The Commission has issued the enclosed Amendment No. 125, to Facility Operating License No. DPR-52 for the Browns Ferry Nuclear Plant, Unit 1. This amendment is in response to your application dated August 23, 1984 (TVA BFNP TS-199), as supplemented September 4 and November 13, 1984, April 3, May 8, June 27, November 20 and December 30, 1985 and April 29, 1986.

BROWNS FERRY NUCLEAR PLANT, UNIT 2

Amendment No. 125
License No. DPR-52

SAFETY EVALUATION BY THE OFFICE OF NUCLEAR REACTOR REGULATION
SUPPORTING AMENDMENT NO. 125 TO FACILITY OPERATING LICENSE NO. DPR-52
TENNESSEE VALLEY AUTHORITY
BROWNS FERRY NUCLEAR PLANT, UNIT 2
DOCKET NO. 50-260

τ
Figure 3.5.K-1

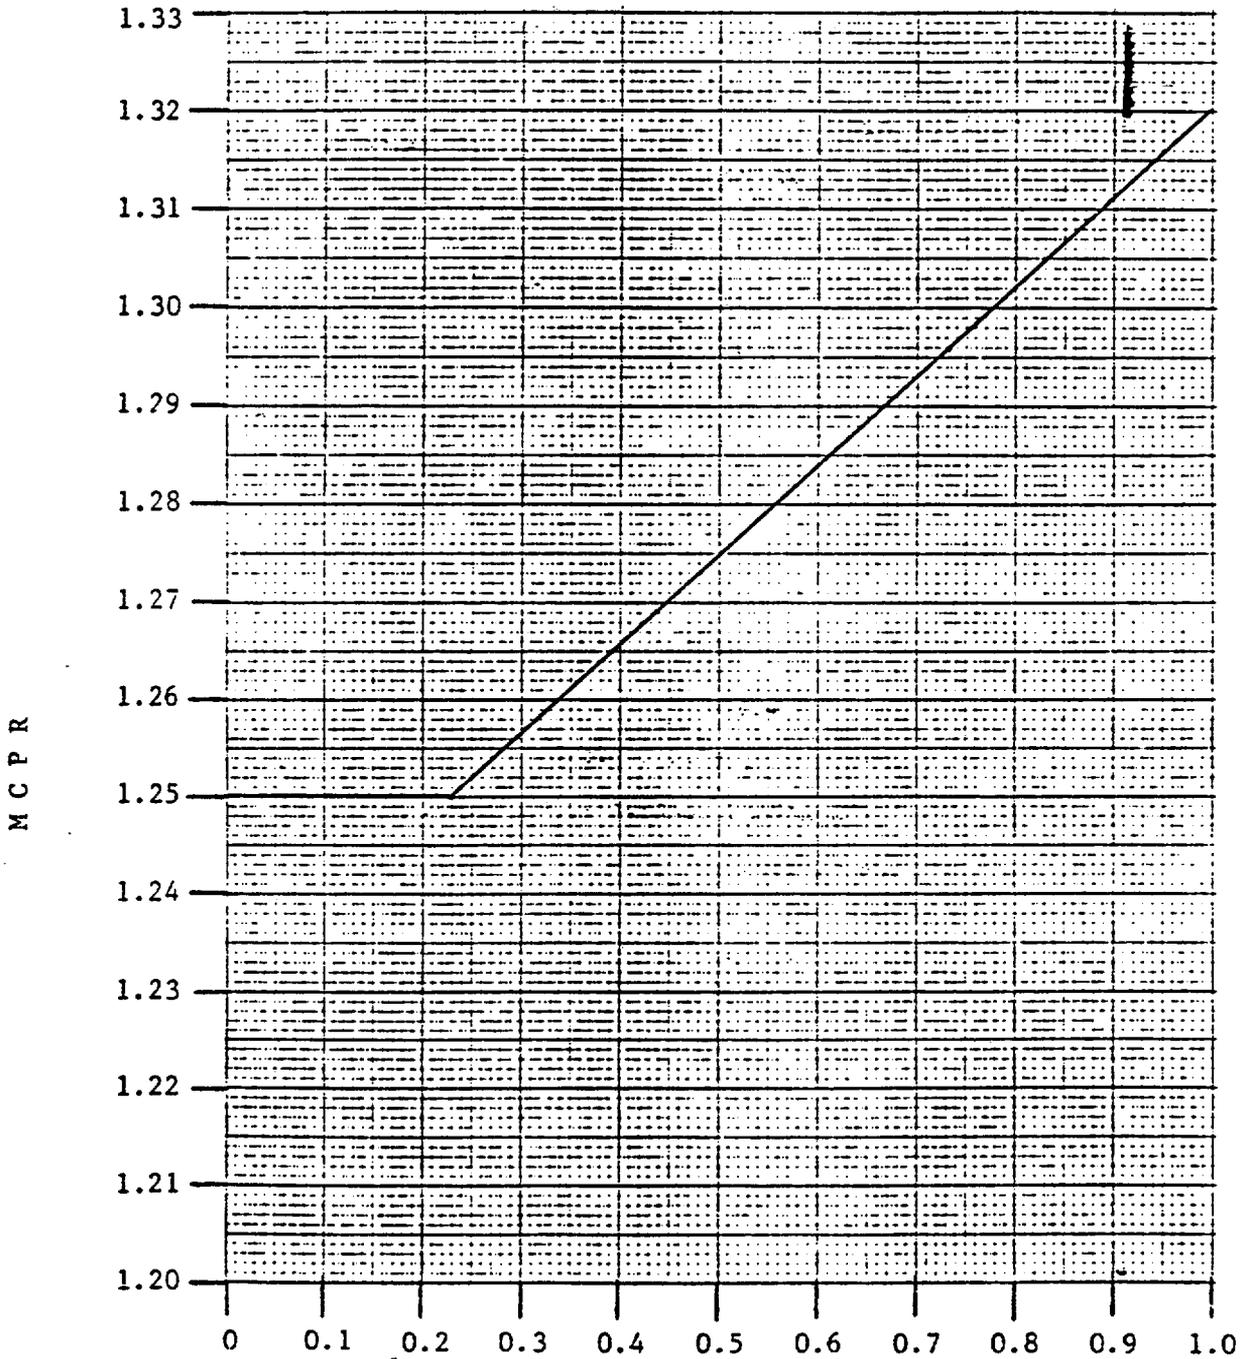
The operating limit MCPR as a function of average scram time, τ , has been altered to account for the Cycle 6 reload. The proposed curve (Figure 3.5.K-1) is consistent with the value given in the reload report (Reference 1) and is acceptable.

The minimum critical power ratio (MCPR) as a function of scram time and core flow, shall be equal to or greater than shown in Figure 3.5.K-1 multiplied by the K_f shown in Figure 3.5.2, where:
